CENTRAL OTAGO DISTRICT COUNCIL
REQUESTED PLAN CHANGE 14 :
NEW ZEALAND CHERRY CORP (LEYSER) LP LTD, CROMWELL : PC 00014
REPORT OF PLANNING CONSULTANTS PURSUANT TO SECTION 42A OF THE
RESOURCE MANAGEMENT ACT 1991

Figure 1: SISD for Approach to Right Turning Traffic on Ripponvale Road

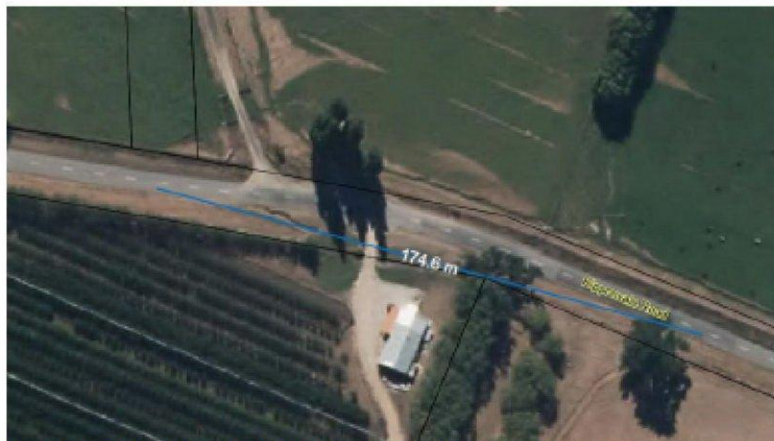
The reporting does not set out any rationale for the choice of access location on Ripponvale Road. Having reviewed other documents in the Plan Change request, we have not identified any further justification for the access location onto Ripponvale Road. However, it appears to have been chosen to line up with an existing unformed legal road. At that location there is limited interaction with adjacent or opposite accesses.

Figure 2: Daily Traffic Volume, Adoption of Queensdown Bias Traffic Distribution

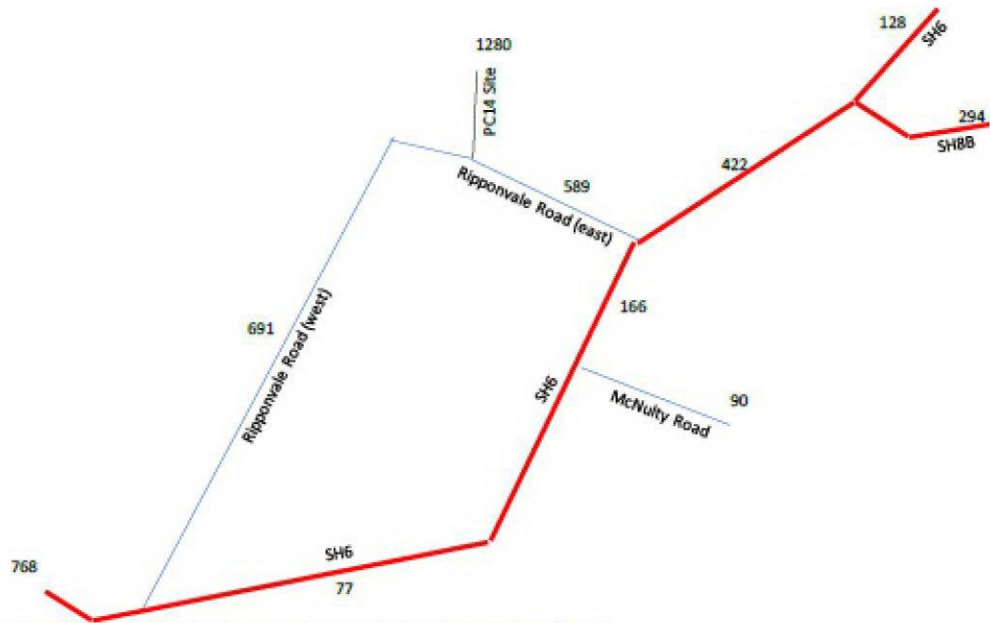
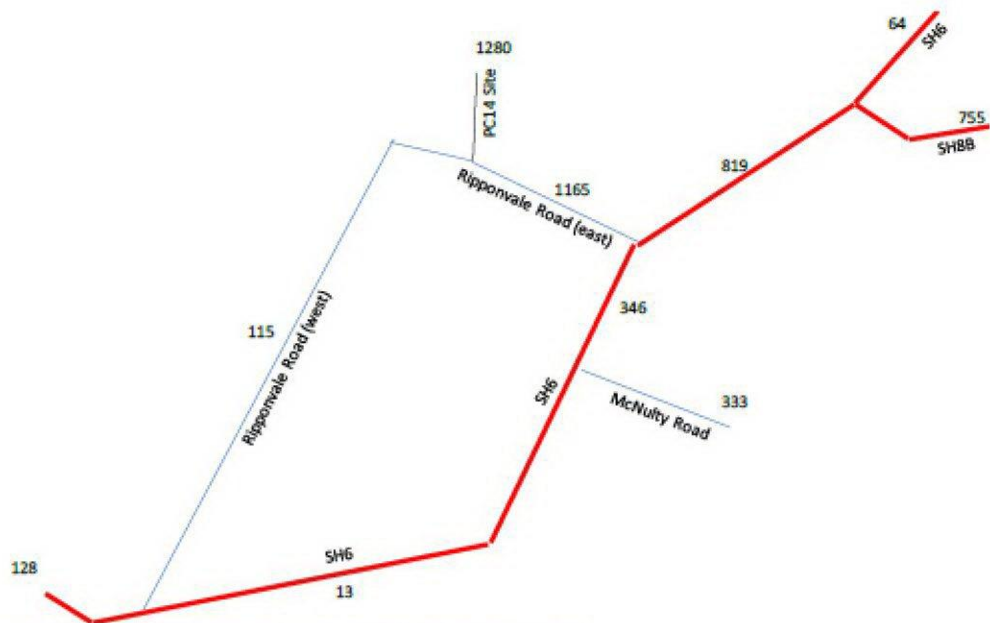
We have produced diagrams below indicating potential additional daily traffic volumes on various routes based on the assessed distributions, and our comments on route choice. In the context of existing traffic volumes, the greatest change will be on Ripponvale Road, which currently carries traffic volumes approximately 250vpd and will increase by 600-1200vpd on Ripponvale Road (east), and 100-700vpd on Ripponvale Road (west).

State highway traffic volumes could increase by up to 800vpd on parts of SH6. This would be an approximately 15% increase on existing SH6 traffic volumes. In the Queenstown bias scenario, this occurs over a long stretch of SH6, whereas in the Cromwell bias scenario, the change is on shorter local sections of the road network.

Figure 9: Spectral Analyses at Location N3

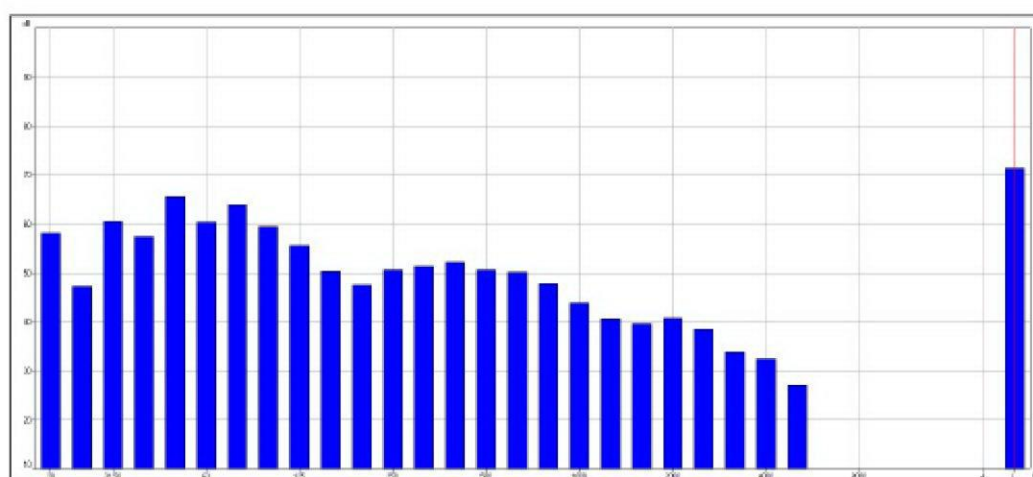
15. It was determined from the spectral analyses (see Figure 9 above) that no one-third octave band exceeded the level differences as per Table 1 and therefore no tonal adjustments to the measured levels were required.

Figure 10: Areas with no measurement data

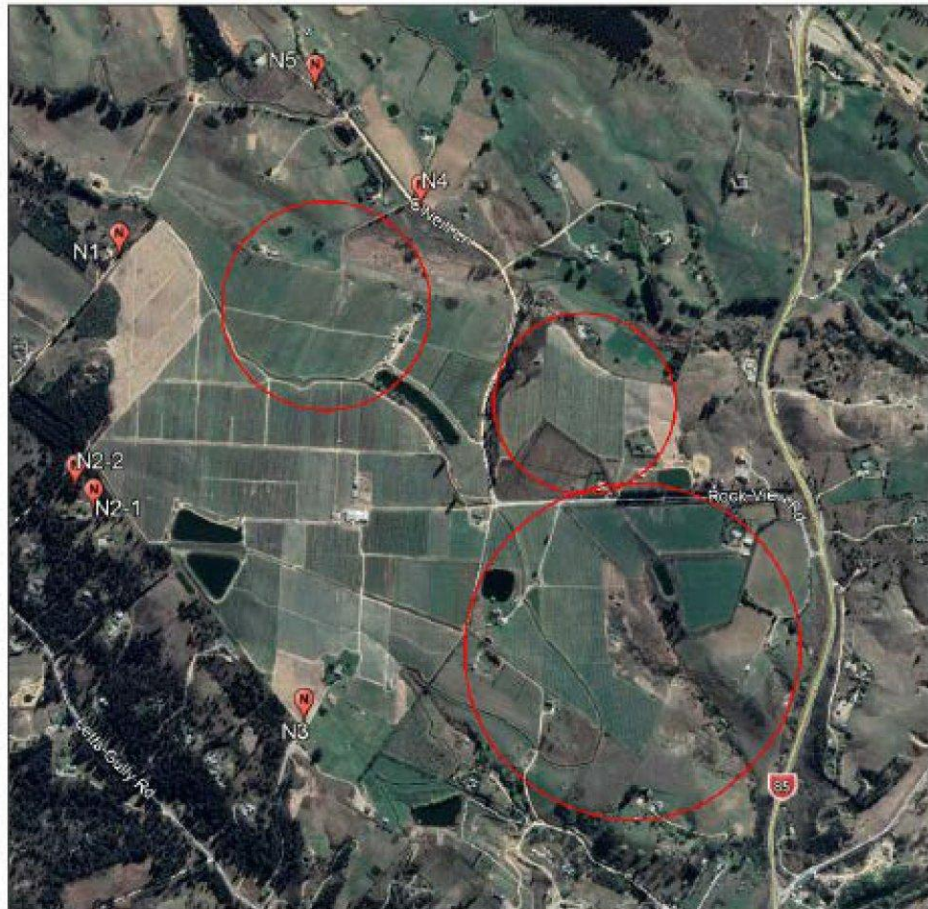
18. Due to time frame constraints undertaking the measurements it was not possible to cover all areas around the site. No measurements were taken in areas to the immediate east and north of the Leaning Rock Cherries Ltd property, (refer to figure below with indicated areas). Therefore, the full extent of the cumulative noise effect in these areas is not certain.

19. With reference to the noise level measured at N4 (63dB LA10), it is reasonable to assume that the likely noise level at the properties of 93 O'Neil Lane, 15 O'Neil Lane and 4 O'Neil Lane which is the nearer to the , will be higher and unlikely to comply with Standard 4.7.6 E (c). However, the areas identified to the east will be less effected due to only one frost fan within a distance of 210 meters from the nearest dwelling and likely to comply with Standard 4.7.6 E (c).
